SAFETY EVALUATION BY THE OFFICE OF NEW REACTORS

RELATED TO AMENDMENT NO. 156

VOGTLE ELECTRIC GENERATING PLANT, UNIT 3

By application dated October 19, 2018, titled, "Request for License Amendment: Column Line 1 Wall Reinforcement Area Change," (Agencywide Documents Access and Management System (ADAMS) Accession No. ML18292A660) and designated License Amendment Request (LAR) 18-026, the Southern Nuclear Operating Company (SNC) requested that the Nuclear Regulatory Commission (NRC) amend Vogtle Electric Generating Plant (VEGP) Unit 3, Combined License (COL) Number NPF-91. The proposed amendment would depart from the AP1000 Design Control Document (DCD) Tier 2* material that has been incorporated into the Updated Final Safety Analysis Report (UFSAR) by changing the vertical reinforcement information provided in the VEGP Unit 3 column line 1 wall from elevation 135'-3" to 137'-0". The requested amendment also proposes related changes to UFSAR Tier 2* information in UFSAR Table 3H.5-3 and UFSAR Figure 3H.5-3.

An example sketch of how the mechanically headed #8@12" vertical reinforcement would be placed at elevation 135'-3" is shown below:

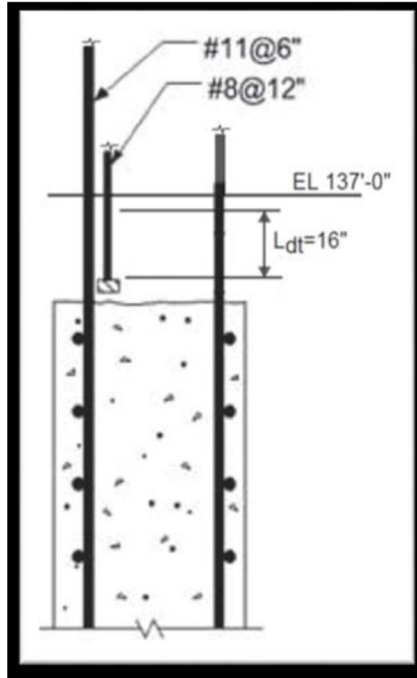
The design of the auxiliary building Wall 1 from elevation 117'-6" to elevation 135'-3" requires outer layer reinforcing bar (also called rebar) curtains (north and south face) consisting of #11@6" vertical bars with #11@6" horizontal bars. A second layer of #8@12" vertical bars is required to begin development length below elevation 135'-3" and extending splice length above elevation 135'-3" on the south face only. There were no second layer #8@12" vertical bars installed in the south face for the entire length of Wall 1 around elevation 135'-3" prior to concrete placement of Wall 1 from elevation 117'-6" to elevation 135'-3". This results in a reinforcement area and configuration that deviates from the Tier 2* information contained in UFSAR Table 3H.5-3 and Figure 3H.5-3. The impacted area is a subsection of wall Section 1 and 6 as shown on UFSAR Figure 3H.5-2.

The proposed changes involve the #8@12" vertical rebar being installed around elevation 135'-3" with a mechanically headed reinforcement (T-head), providing full development of the bars at and above elevation 137'-0", in accordance with American Concrete Institute (ACI) 318-11, "Building Code Requirements for Structural Concrete." Due to this change, the provided minimum amount of reinforcement area is less than the existing UFSAR Table 3H.5-3 provided minimum value of 3.91 square inches per foot (in²/ft) between elevation 135'-3" and elevation 137'-0". The actual provided value is 3.12 in²/ft. SNC's evaluation determined a maximum required area of steel, along the entire evaluated length of wall between elevation 135'-3" and elevation 137'-0", of 2.801 in²/ft, for load combinations which do not consider simultaneous thermal and safe shutdown earthquake loads, consistent with UFSAR Table 3H.5-3 reported values. The resulting interaction ratio (IR) of the conservative refinement for the impacted region is 0.898 (2.801 in²/ft / 3.12 in²/ft). A required area value of 2.81 in²/ft is included in the proposed markups, which conservatively bounds the actual required area of 2.801 in²/ft. Since the IR is less than 1.0, this change is acceptable and continues to satisfy the acceptance criteria of the ACI 349-01, "Code Requirements for Nuclear Safety Related Concrete Structures," and applicable design criteria.

The staff reviewed UFSAR Subsection 3H.5.1.1 and applicable ACI 318-11, "Building Code Requirements for Structural Concrete (ACI 318-11)," and ACI 349-01 code provisions pertaining to concrete, critical sections and loads. The development length of a #8 headed reinforcement in tension is 16", consistent with ACI 349-01 and ACI 318-11, Section 12.6, "Development of Headed and Mechanically Anchored Deformed Bars in Tension." Given the existing construction joint at elevation 135'-3", the available height of wall to develop the bars prior to elevation 137'-0" is 21".

Therefore, the installation of these bars using a headed reinforcement ensures that the bars will be fully developed at elevation 137'-0" and above, consistent with provisions of ACI 318-11. The staff finds that the change to the reinforcement area between elevation 135'-3" and elevation 137'-0" is in accordance with and continues to satisfy the acceptance criteria of ACI 349-01 and ACI 318-11 and has no adverse impact on the seismic response of Wall 1. The change does not significantly impact the approved design and Wall 1 will continue to withstand the design basis loads without loss of structural integrity or the safety-related functions.
